# parts bulletin

**QUICKSILVER**<sup>®</sup>  
MARINE PARTS AND ACCESSORIES

No. 95-10

## NEW QUICKSILVER ALUMINUM PROPELLERS - MARINER/ MERCURY 30 - 60, FORCE 40 - 70

**ADDITIONAL CUP ALUMINUM PROPELLER -  
P/N 48-42738A12  
12 1/2 INCH DIAMETER X 8 INCH PITCH**

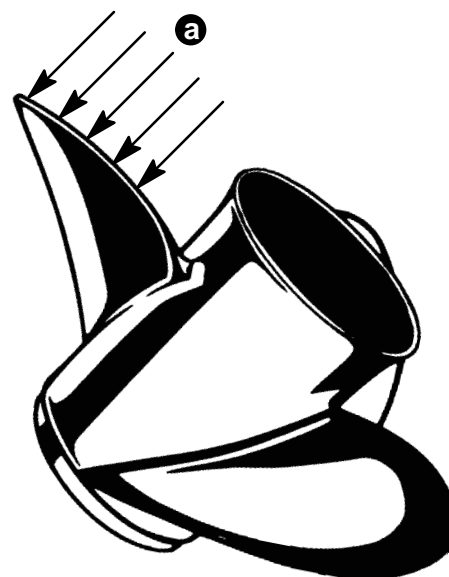
This propeller allows pontoon and work applications increased performance by reducing cavitation experienced on some applications during turns and maneuvering.

**a** Additional Cup – Trailing Edge
